Piper Aircraft Corporation
Vero Beach, Florida, U.S.A.

SERVICE No. 811A
BULLETIN

(Service Bulletin No. 811A supersedes and voids Service Bulletin No. 698A, dated August 17, 1982 and Service Bulletin No. 811, dated January 8, 1986)

Ammeter Replacement

SKETCH "A"

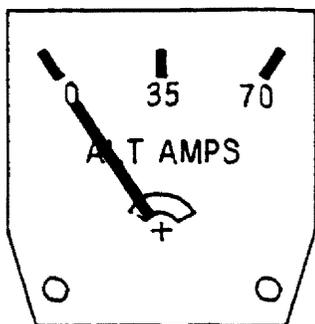
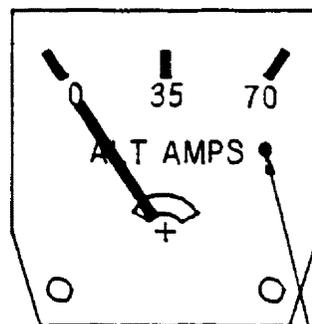
PURPOSE: Engineering tests have determined that a number of ammeter gauges shipped in support of Service Bulletin No. 811 were not correctly calibrated. Correctly calibrated gauges may be identified by the presence of a white dot located on the righthand side of the ammeter face, immediately following the word "AMPS". See Sketch "A" attached. Incorrect ammeter indications could lead to inadvertent overcharging and/or depletion of the aircraft's battery with subsequent loss of battery electrical power.

1. All aircraft which have complied with Service Bulletin No. 811 must inspect for the presence of a white dot on the righthand side of the ammeter face. See Sketch "A" attached.
2. If white dot is not present, the ammeter gauge, only, must be replaced with a correctly calibrated gauge.
3. Using applicable instructions for the Ammeter Replacement Kit, Piper Part Number 765-186, replace the newly installed ammeter only, with Ammeter, Piper Part Number 763-053.

AMMETER THAT HAS NOT
BEEN CALIBRATED.
NOTE ABSENCE OF IDENTIFICATION DOT

AMMETER THAT
HAS BEEN CALIBRATED
IDENTIFICATION DOT

It should be noted that Part Number 687-277 ammeter is manufactured by Rochester Gauges, Inc., and it does not have an identification dot to indicate calibration.
